5.3 NO. 12 BROOKMAN STREET (LOTS: 69 AND 90; PLAN: 4576) - PROPOSED ALTERATIONS AND ADDITIONS TO SINGLE HOUSE

RECOMMENDATION:

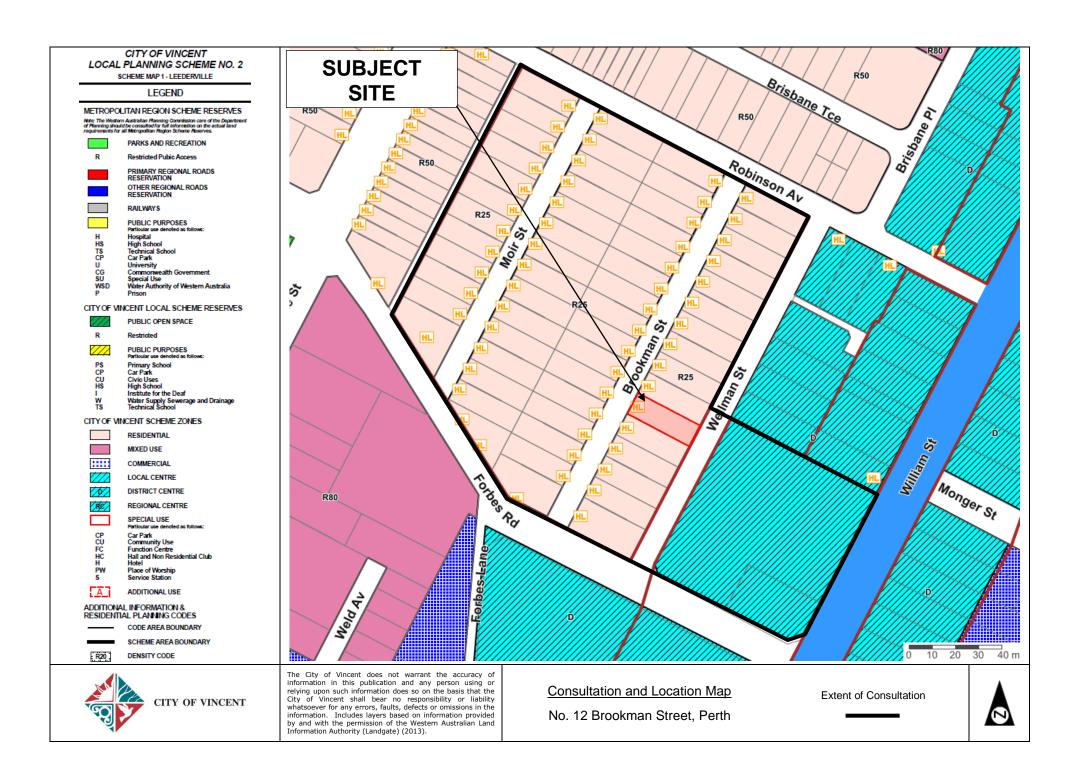
The location of the rear water closet on site is consistent with that shown in the 2005 plans and marked on sewerage maps prepared in 1951. Correspondence with the landowner in 2005, who is the same as the current landowner, about the development of the carport and store noted the presence of the 'heritage water closet' at the rear would be unaffected by the proposal.

A site inspection by Administration as part of this assessment noted the presence of rendered masonry walls to the south west and south east elevations of the rear water closet. The north west and north east elevations consisted of new masonry and stud-framed walls respectively. The above leads Administration to conclude that while the water closet has been modified, there is original brickwork remaining.

OVERSHADOWING:

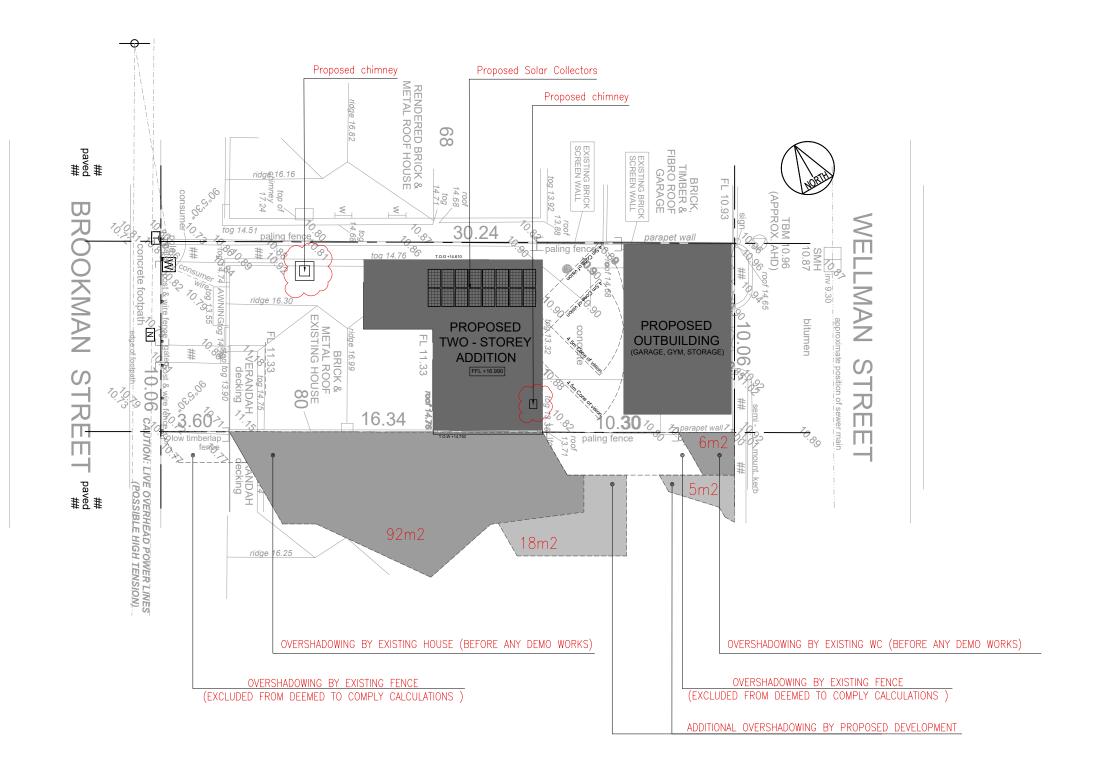
Co	nments Received in Objection:	Applicant Comment:
	•	
•	The proposed overshadowing (44.7%) would diminish the sunlight and air to the neighbouring property's outdoor living area and their solar access from the north. It is important that all houses in the precinct have equal opportunity to make use of natural sunlight in outdoor living spaces for the health and wellbeing of occupants and for effective solar access.	This Concern was addressed and the overshadowing is now significantly reduced. Also noting that the majority of the overshadowing is from the common wall and fence with the neighbouring Property.
